The Office of Vince Ryan
County Attorney

February 24, 2015

Subject: San Jacinto River Waste Pits Superfund Site – Significant Groundwater and Surface Water Concerns

Time Series of TEQ Concentrations in San Jacinto River at I-10

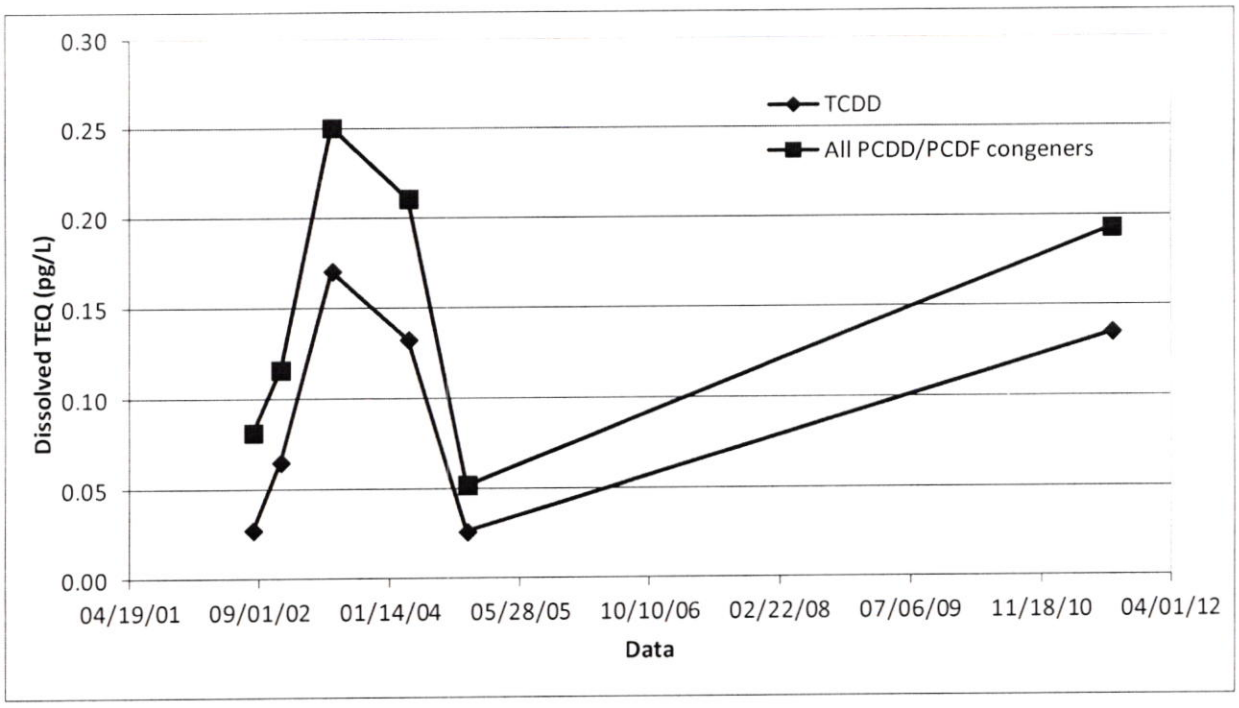
The latest dioxin data from surface water samples collected in the San Jacinto River at I-10 as part of the Houston Ship Channel dioxin TMDL project (August 2011 data provided by TCEQ) do not indicate that dioxin/furan concentrations in water adjacent to the Site are declining. There are no data to assess water concentrations after the cap was put in place, nor to determine the influence of groundwater contamination on the receiving surface water.
